SUNDRY NOTICES AND REPORTS ON WELLS (DO NOT USE THIS FORM FOR PROPOSALS TO DRILL OR TO DEEPEN OR PLUG BACK TO A DIFFERENT RESERVOIR. USE "APPLICATION FOR PERMIT" (FORM C-101) FOR SUCH PROPOSALS.)		WELL API NO. 30-005-10586

Cano Petro Of New Mexico
Cato San Andres #069
API: 30-005-10586
Chaves County, New Mexico

Plug And Abandonment Procedure

Cato San Andres #069

Existing Wellbore Diagram

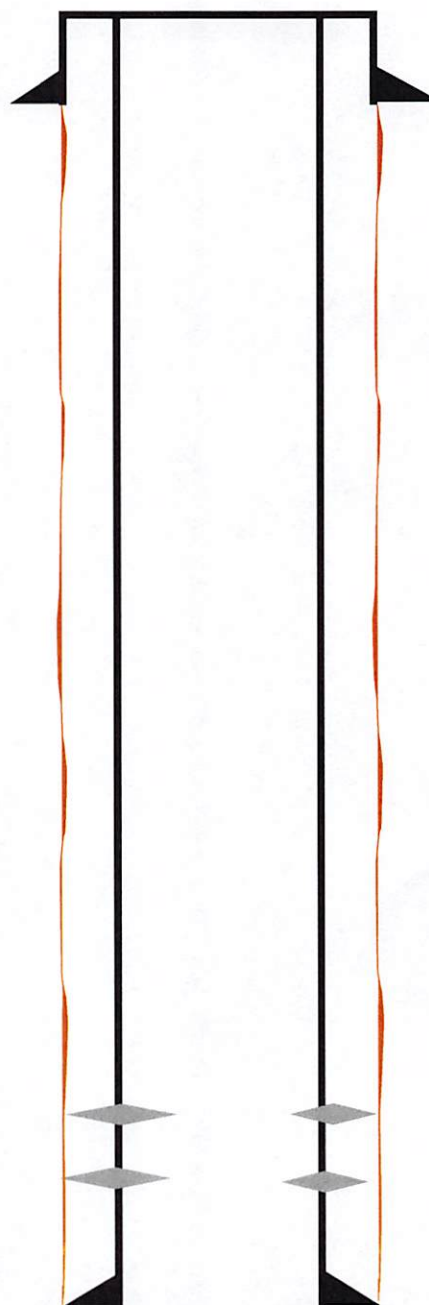
APPROVED WITH CONDITIONS

Perf & Sqz all
 plugs above plug 1

Adhere to NMOCD
 COAs attached.
